10/14/08  
73FR 60726

## GOT WATER?

Progress Energy Florida  
**Levy Nuclear Plant  
 Units 1 and 2**  
 Part 3, Environmental Report  
 LNP REMP Sampling Locations  
 FIGURE 6.2-3  
 Rev 0

USGS website: [wdr.water.usgs.gov](http://wdr.water.usgs.gov)  
Tidewater #1 – Floridan Aquifer System

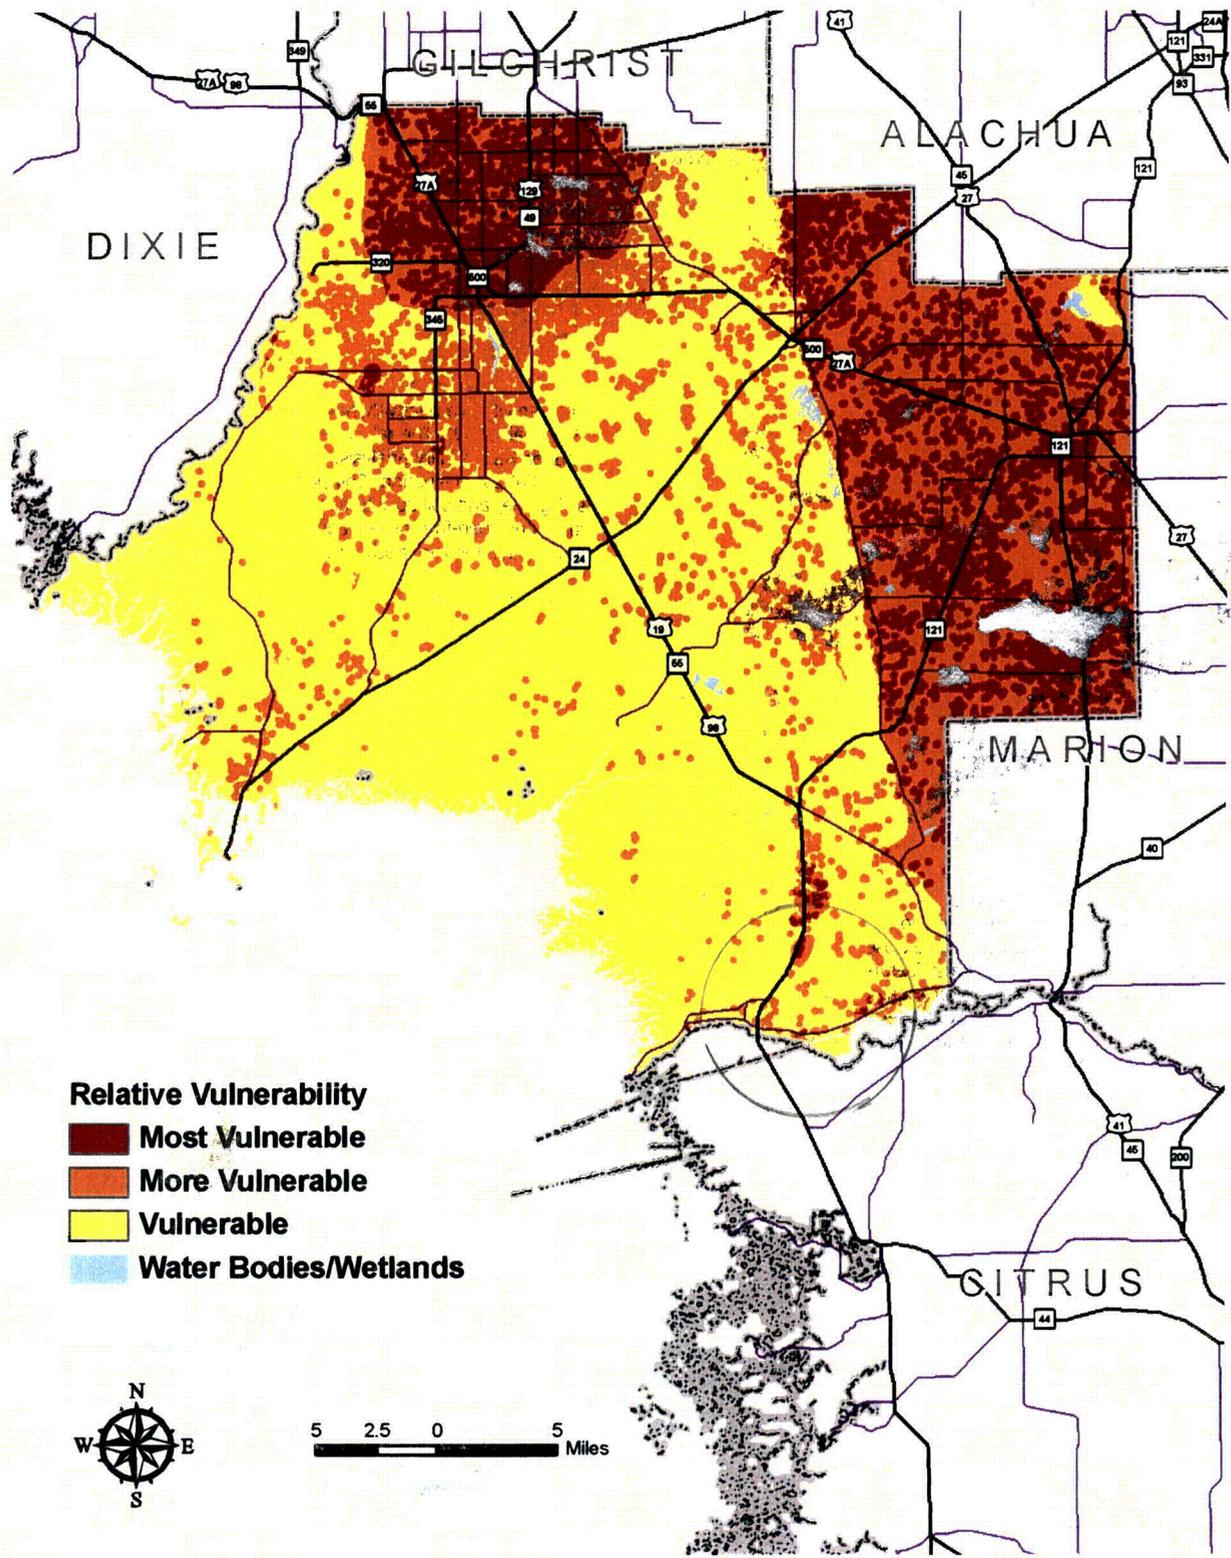
Progress Energy's environmental report documents all wells in the area that have been used in the past for monitoring quantity and quality , except for ONE – *Tidewater*.

**The very one that is active, monitored and recording everyday.** It is north and a little east of the proposed plant location and thus gives a good picture of the water flowing within the Floridan Aquifer at any moment. This well for the past several years has been reading in the critical stages. This shows there is already stress on the system – what will 1 **million gallons per day** or more a day, pumped out do to this system?? It is stated by PE that the water movement is west – southwest in the proposed area, which is just in line with the water the well is monitoring.

Exhibit 1

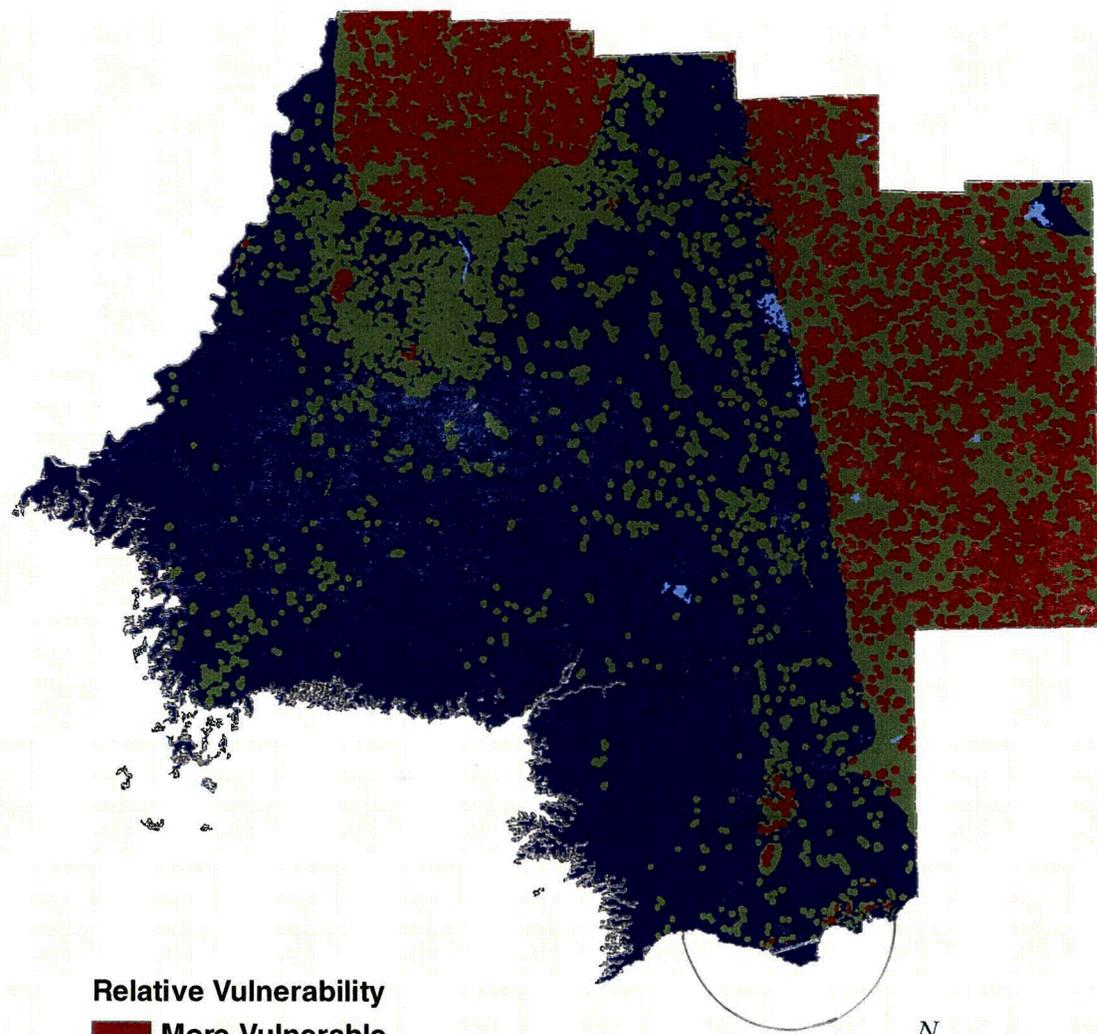
water to the inhabitants of most of the southern part of Levy and Marion County and to the northern part of Citrus County. This small red zone shown on the Levy County, Floridan Aquifer Vulnerability Assessment map (ex.1) shows an area where our groundwater's quantity and quality are extremely vulnerable. It is a very karst area, meaning that the thin limestone covering of the Floridan Aquifer has lots of hole in it (sinkholes in fact) (ex 2), and water can and will flow in many different directions, it just depends on the amount of water in the system!

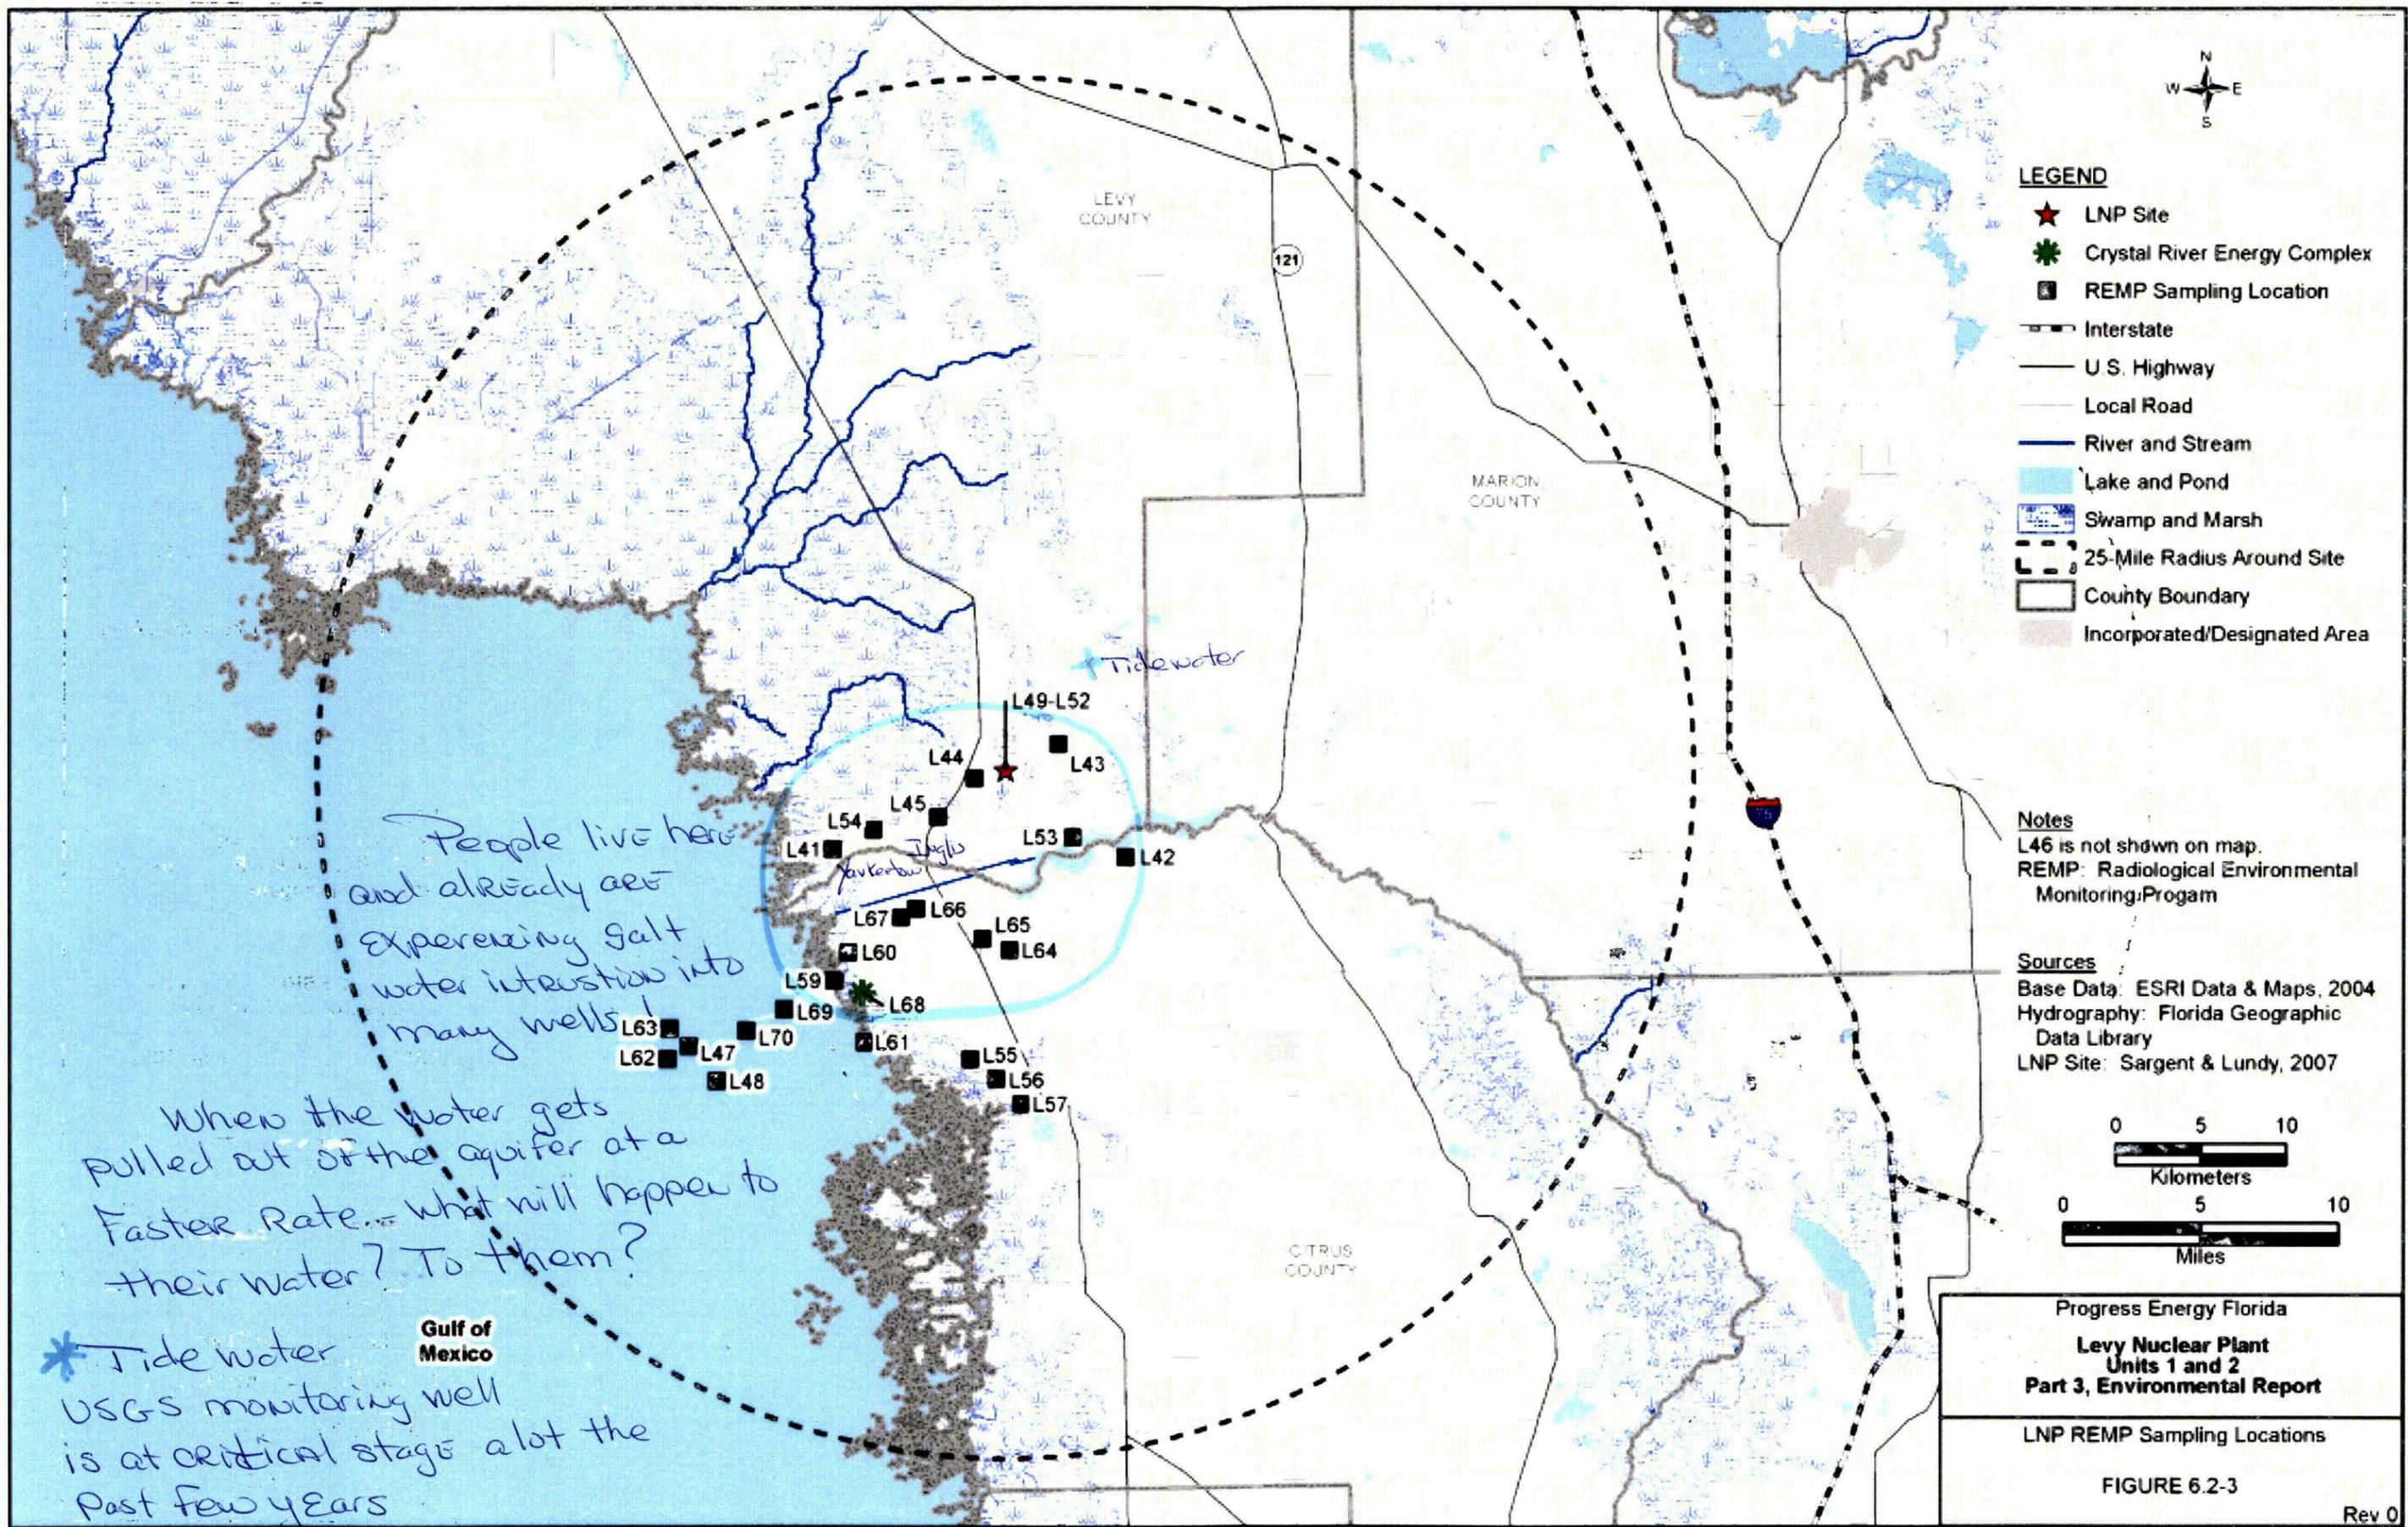
People live here and already are experiencing salt water intrusion into many wells!

When the water gets pulled out of the aquifer at a faster rate... what will happen to their water? To them?

\* Tide water USGS monitoring well is at critical stage a lot the past few years

FIGURE 4.1-3

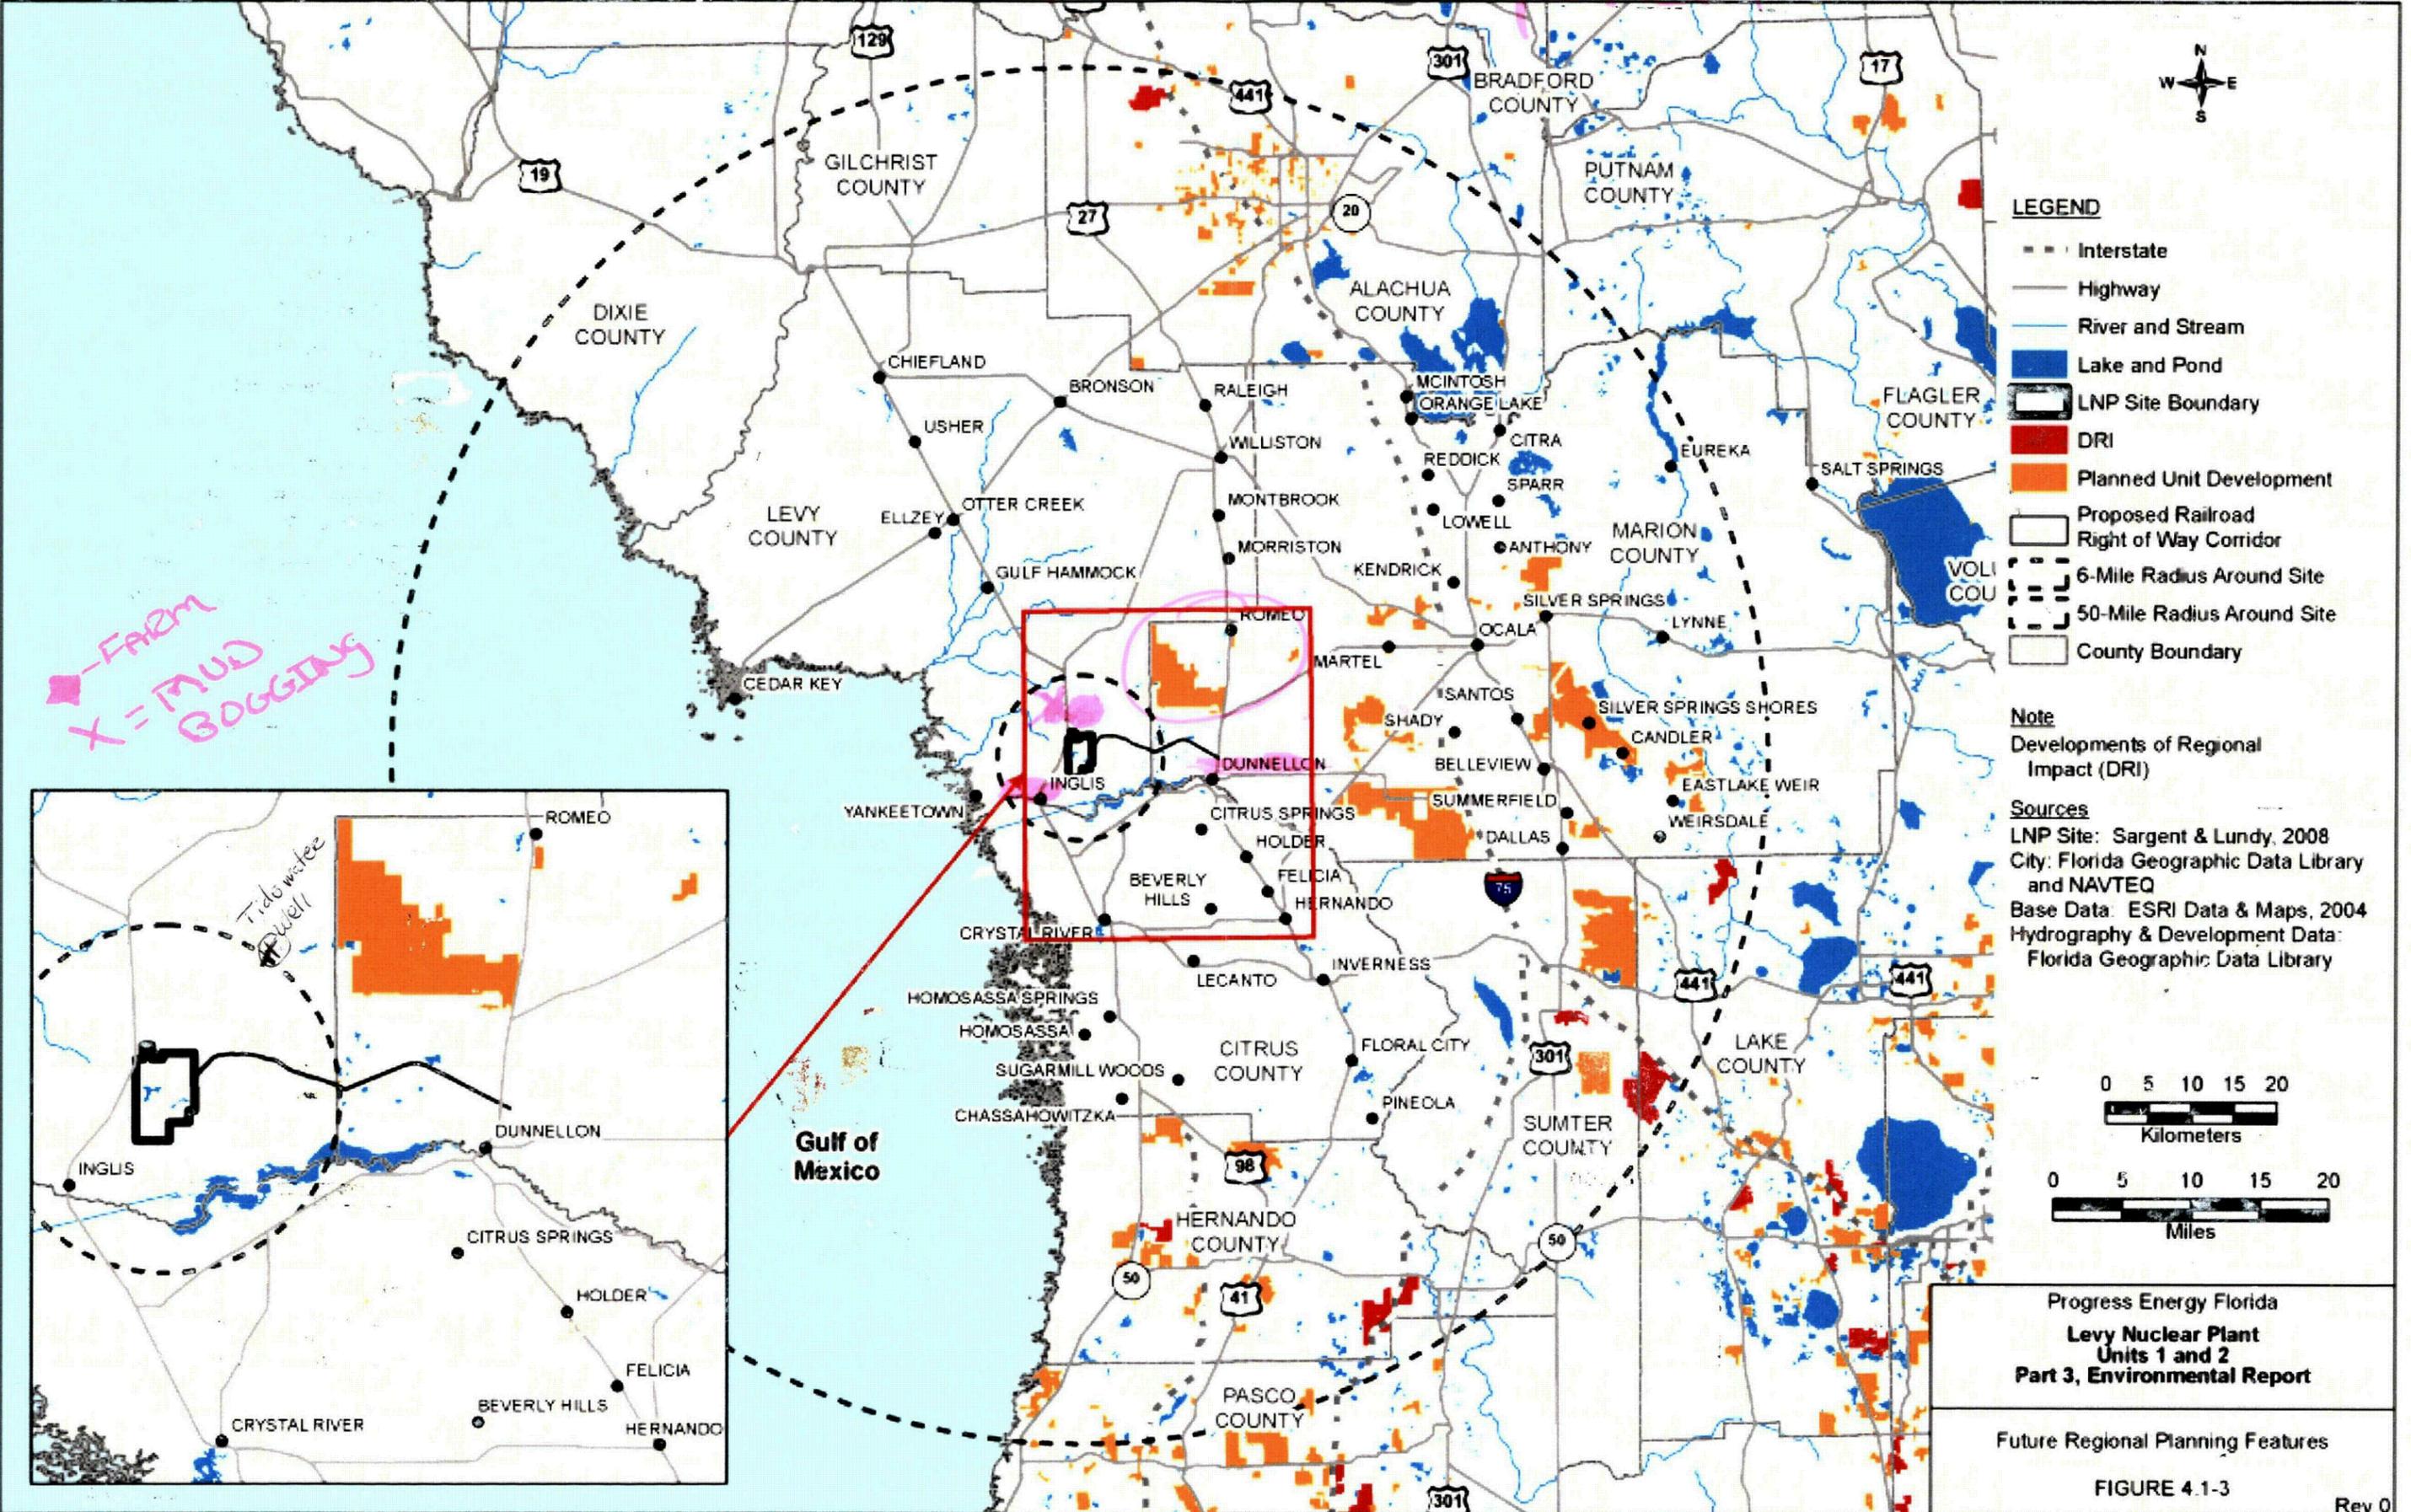
Stress To System
